June 8, 2026

2025-CRW-1028

Re: Addendum No. One (1)
Electric Charging Station
West Virginia International Yeager Airport (CRW)

GI002

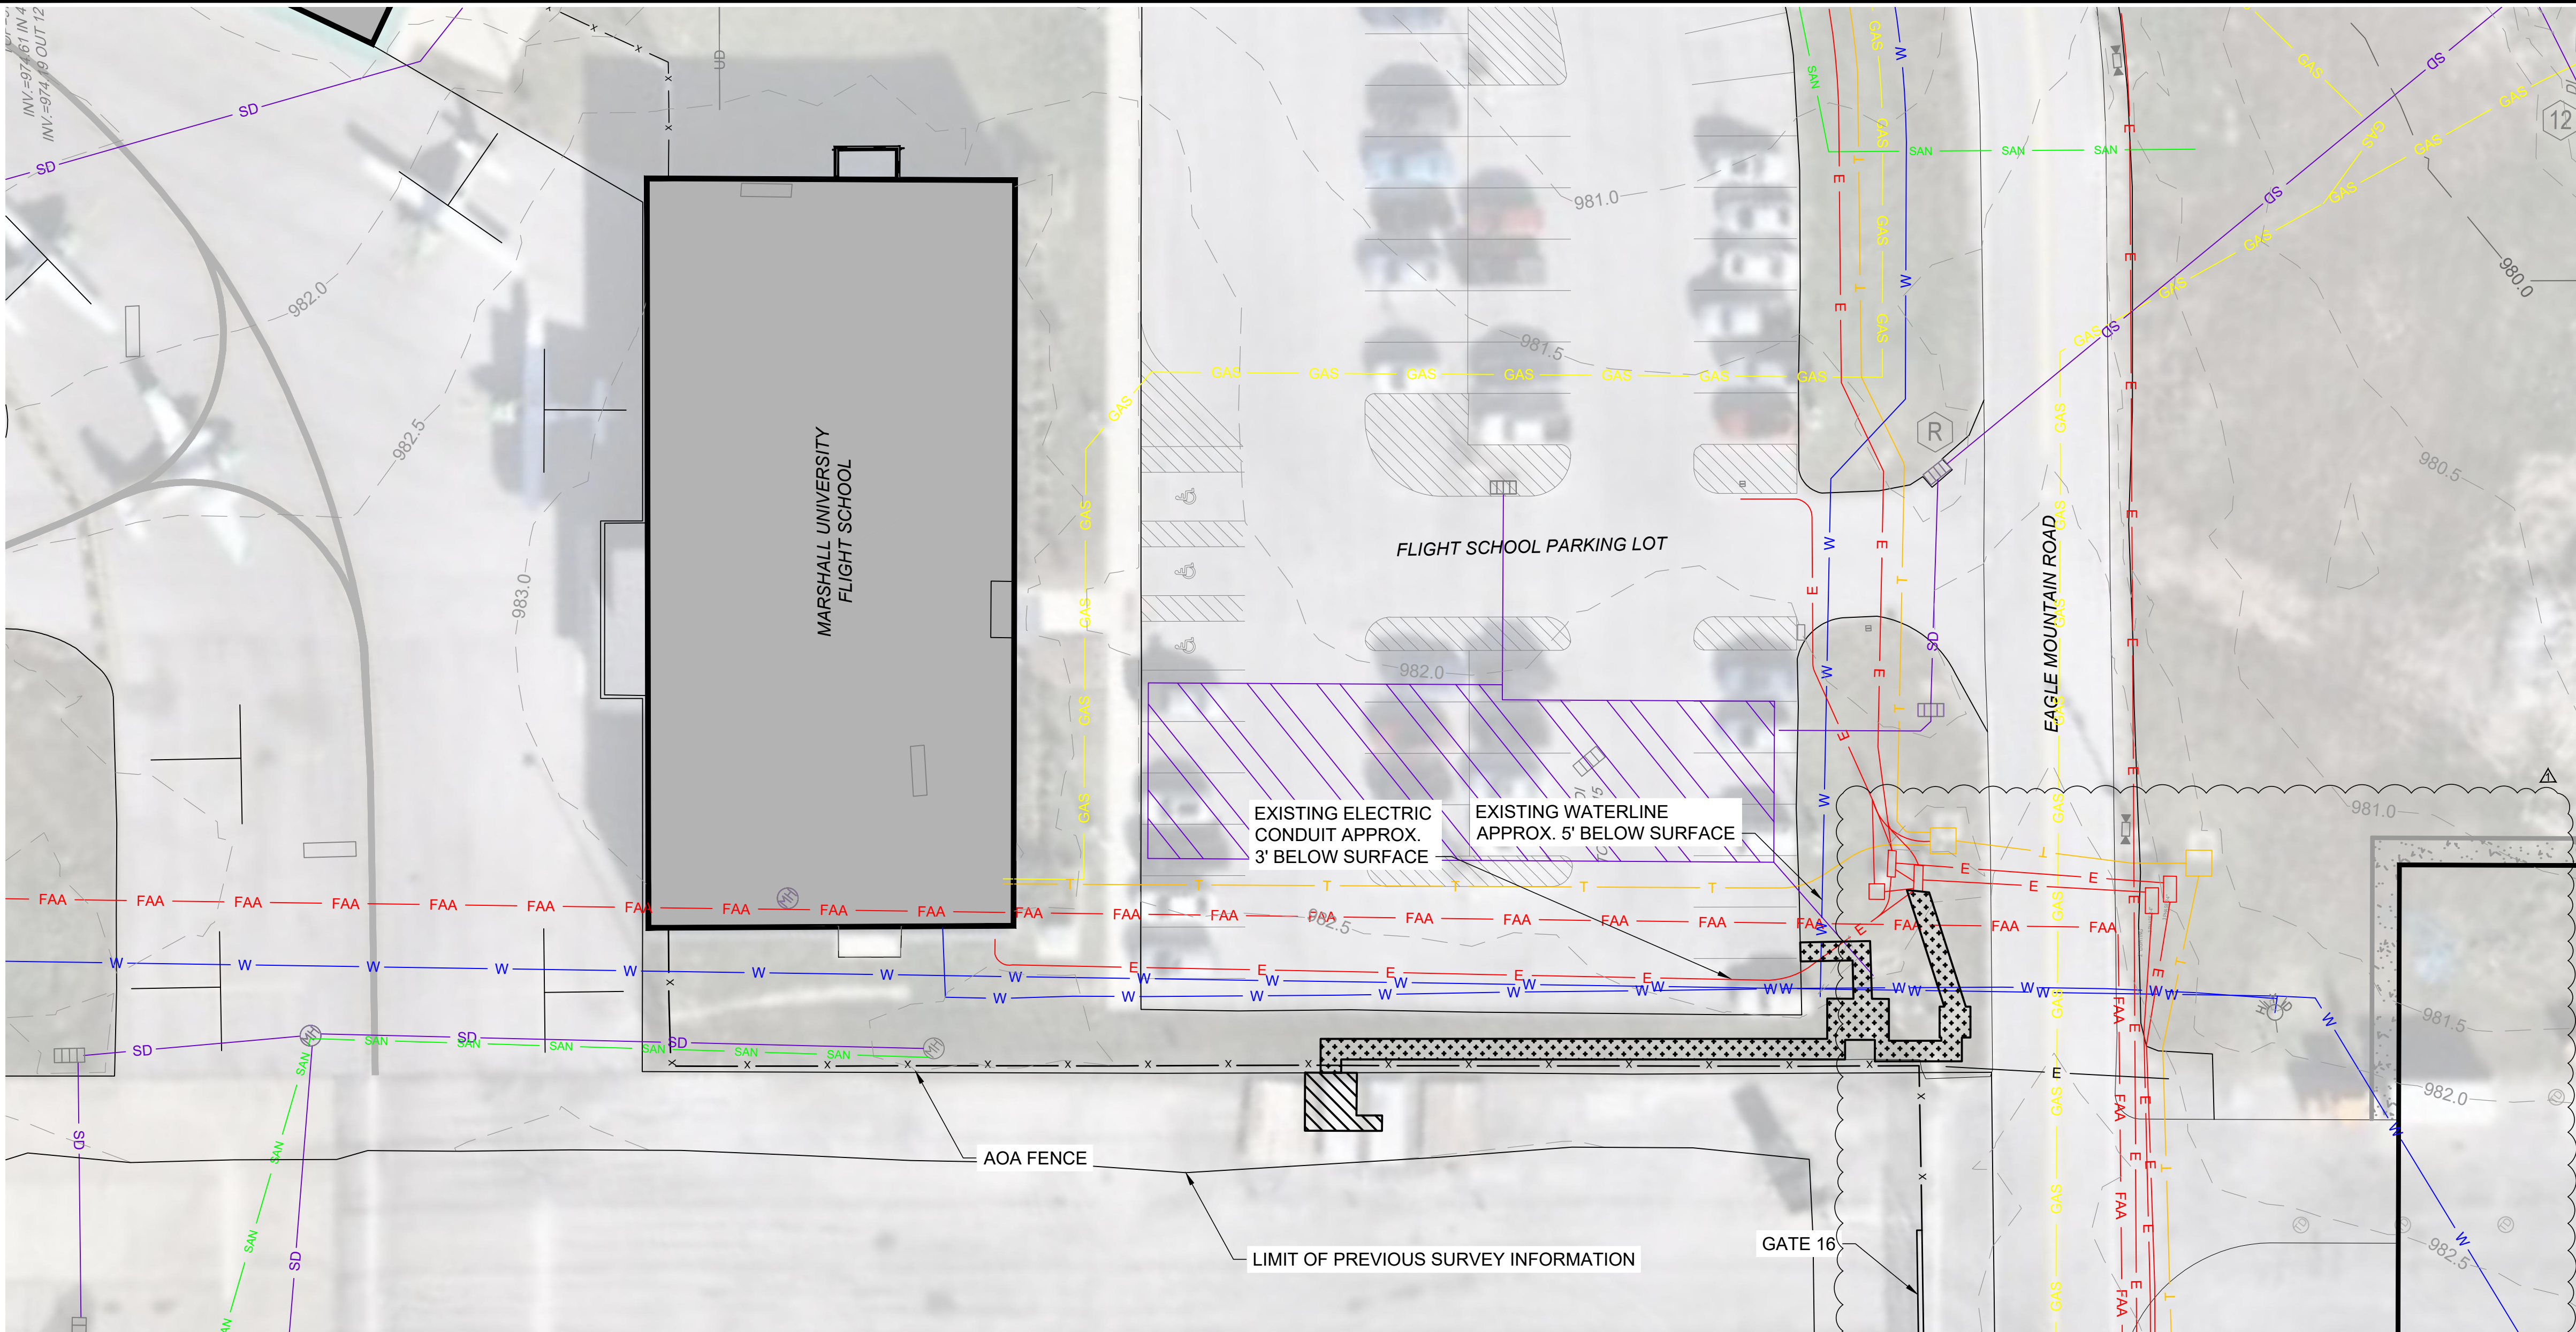
1.05 REPLACE Drawing No. GI002 with new GI002 attached to this Addendum No. One (1)

1.05.1 REVISE Sheet Index to remove Sheet GC300 and CP300

1.05.2 REVISE Schedule of Quantities to reflect changes in ductbank installation

DRAWING NO. CD100

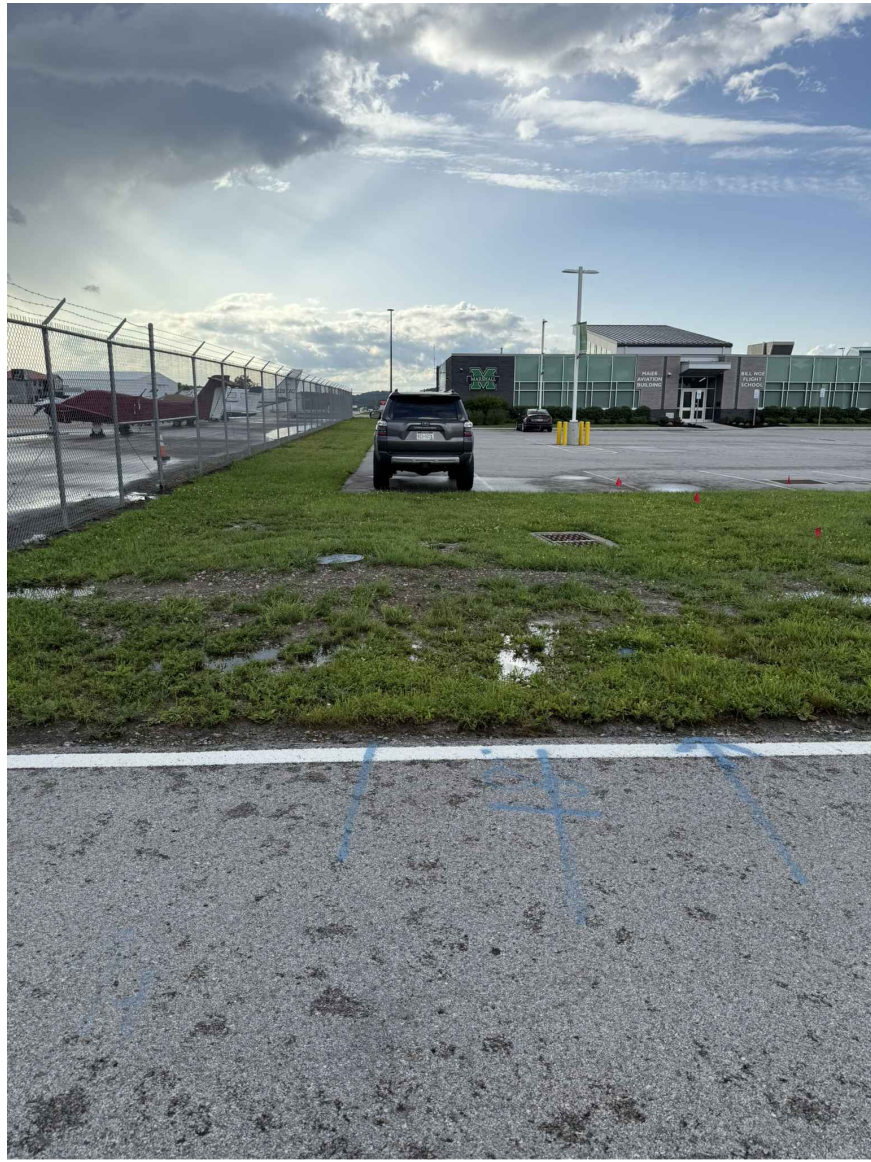
1.07 REVISE Drawing No. CD100 with new CD100 attached to this Addendum No. One (1)

1.07.1 DELETE Site clearing and Asphalt pavement demolition crossing Eagle Mountain Road and parallel to Eagle Mountain Road

- 1.07.2 **ADD** Site clearing demolition to connect proposed equipment to existing equipment
- 1.08 **REPLACE** Drawing No. CP100 with new CP100 attached to this Addendum No. One (1)

CP100

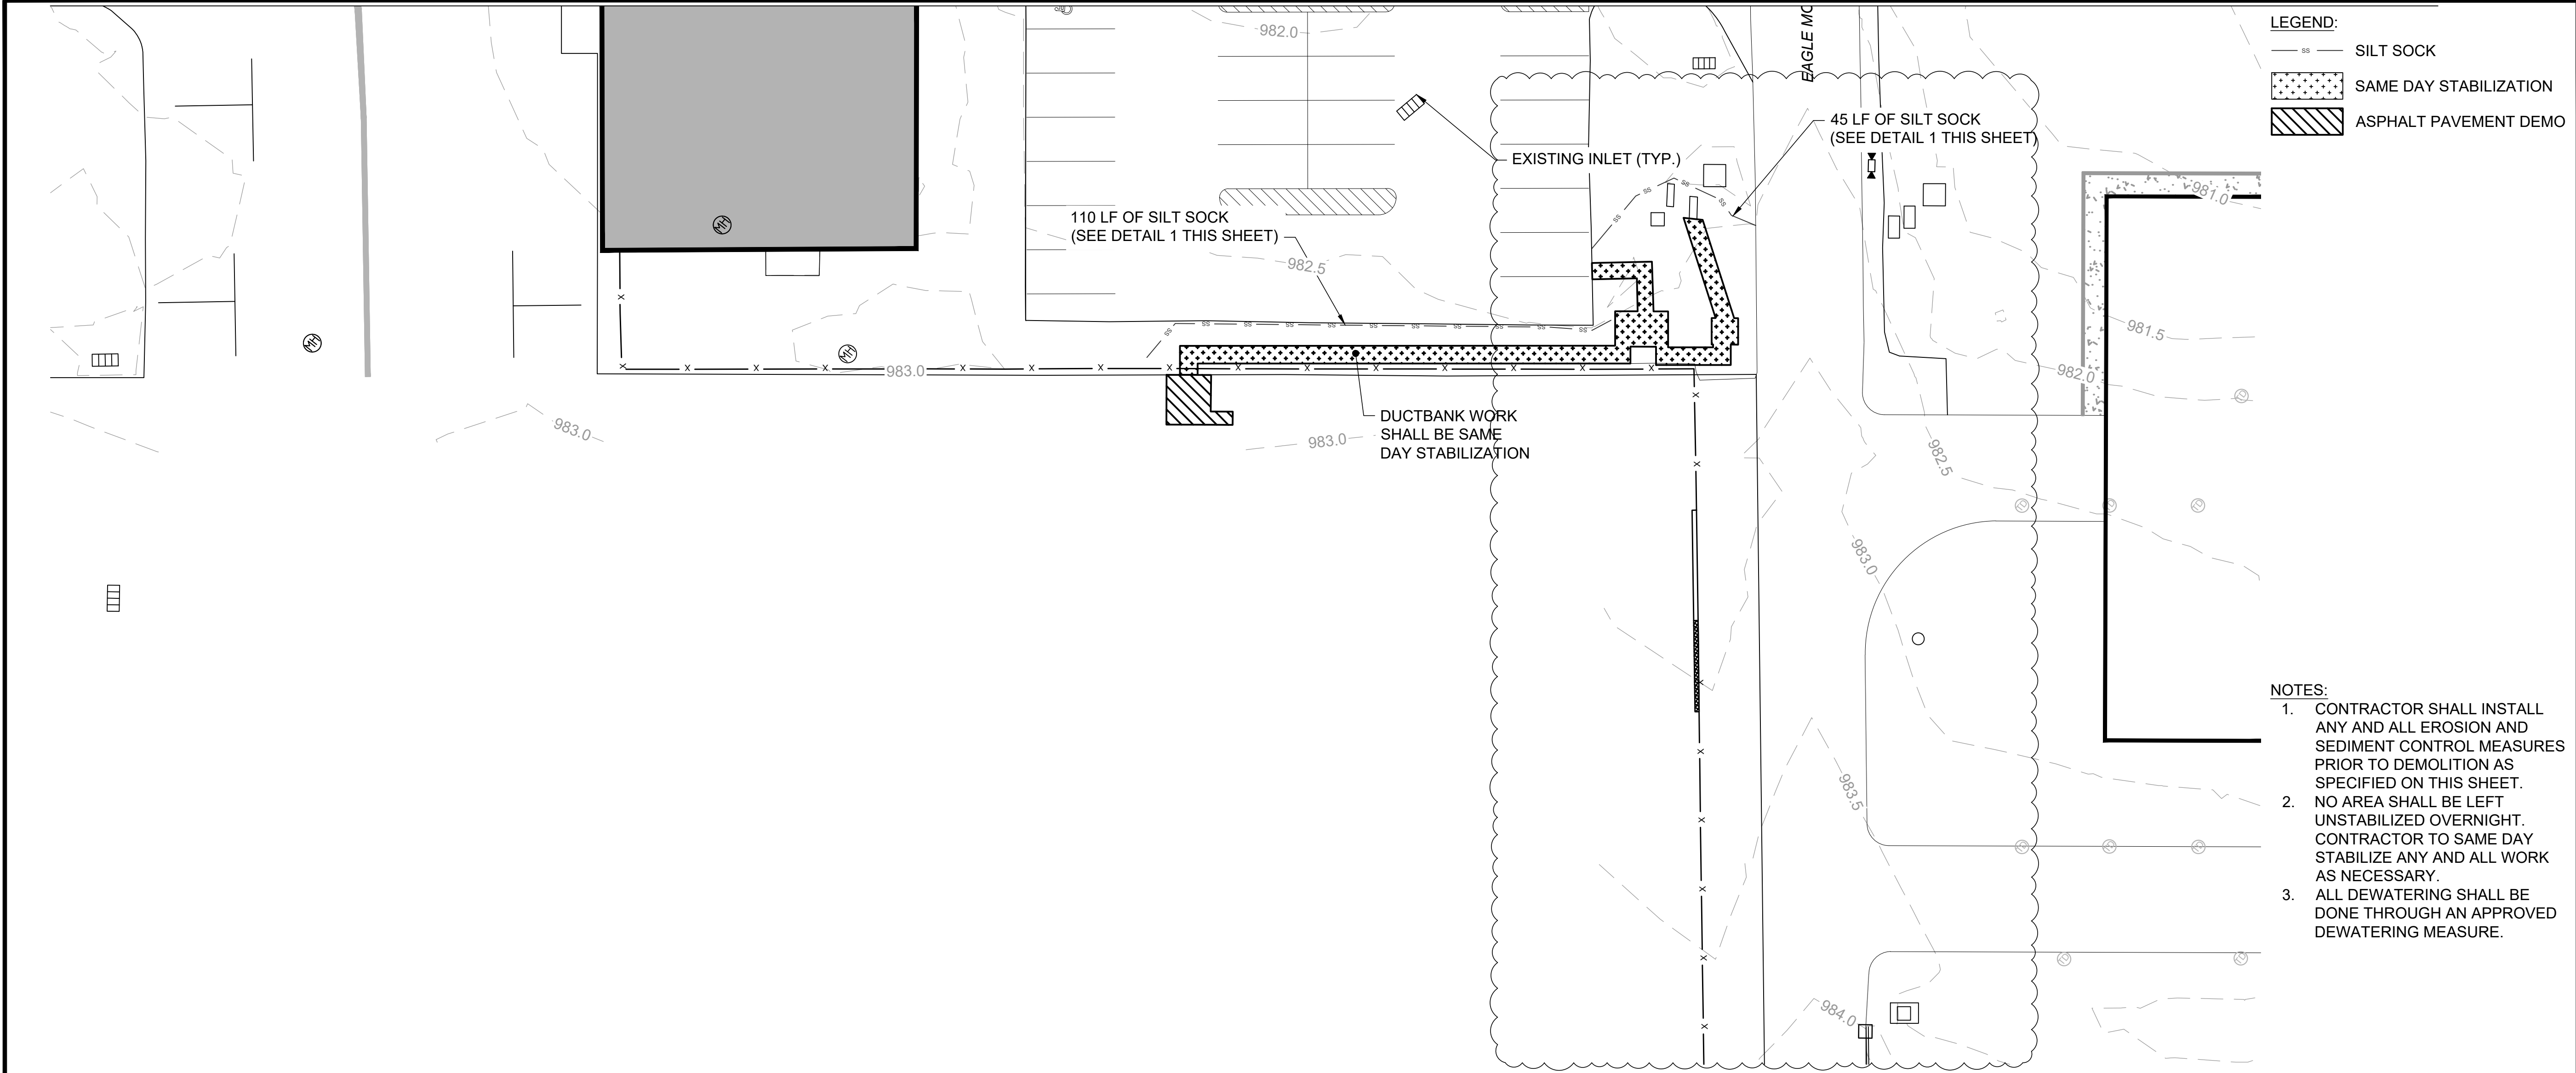
- 1.08.1 **DELETE** 4Way-4" Ductbank crossing Eagle Mountain Road and parallel to Eagle Mountain Road.
- 1.08.2 **DELETE** 3'x3'x3' Handhole
- 1.08.3 **ADD** 4Way-4" Ductbank to connect proposed equipment to existing equipment

- 1.08.4 **REVISE** Equipment pad callout from "Proposed electrical meter and CT cabinet pad (6' x 6') to "Proposed electrical meter and transformer pad (6' x 6')"

- 1.08.5 **REVISE** Sheet Note 3 to include "Car Charger Dispenser" to list of equipment being provided by BETA
- 1.09 **REMOVE** Drawing No. CP300
- 1.10 **REPLACE** Drawing No. CE100 with new CE100 attached to this Addendum No. One (1)

- Q1.** Will the entirety of the 4 way-4" duct bank shown on CP100 that runs from the AEP transformer to the meter/CT pad be installed under this contract including the manhole?

- Q3.** Per drawing CP100, it shows that the SRE building would use the same duct bank and manhole, but the duct bank is only a 4 way-4" which is what is required for the EV charger MDP. Does two 4" conduits need to be added for the SRE project feed from the AEP transformer to the manhole?

- A1.** **The ductbank layout has been revised. The previously shown ductbank adjacent to the proposed Snow Removal Equipment (SRE) building and crossing Eagle Mountain Road has been removed by Addendum No.1. The contractor shall base its bid on the revised drawings included with Addendum No.1.**

- A3.** **There is no need for additional conduits as the ductbank layout has been revised. The previously shown ductbank adjacent to the proposed Snow Removal Equipment (SRE) building and crossing Eagle Mountain Road has been removed by Addendum No.1. The contractor shall base its bid on the revised drawings included with Addendum No.1.**
